Bicycle Pedestrian Advisory Committee
Meeting 9/28/22
Public Comments

From: Ross S. Heitkamp <[REDACTED]>
Sent: Tuesday, September 27, 2022 5:00 PM
To: BPAC Communication <bpac@mountainview.gov>
Subject: 2022-09-28 Meeting Item 6.3 Castro Street Pedestrian Mall

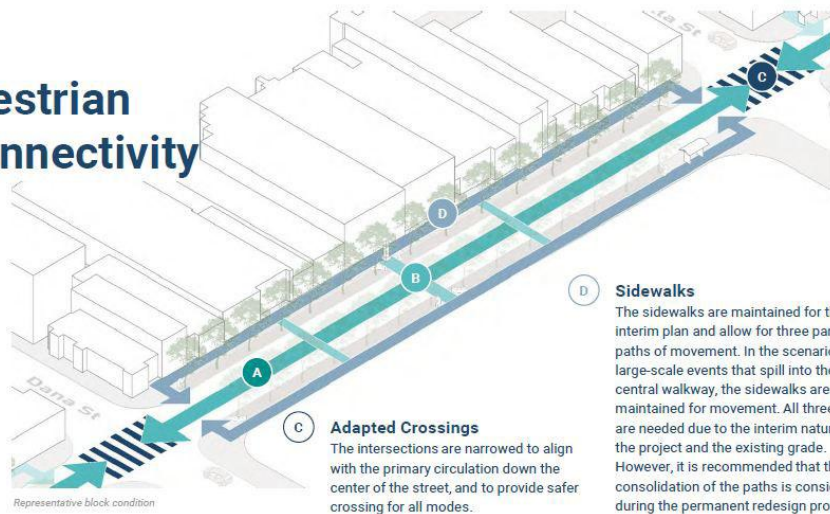
Invite users of all ages and abilities to comfortably and safely access and move on and along the street.

Walk that bike!
